**Harford County HVACR Mechanical Board  
Open Session  
October 12, 2016**

AG-T 32x32 SPECIFICATION SHEET

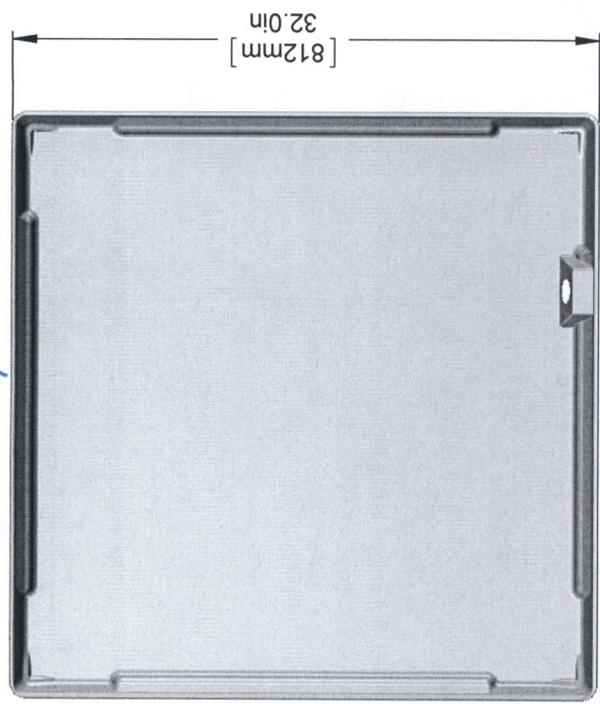
The Board reviewed the plastic pan submitted by Krause Construction Company. The Board determined the pan is code compliant.

SCOTT CAN YOU CALL ME -

R.E. MICHELIS SAID NOT STAMPED ON PART. BUT I THINK THIS IS OK ?
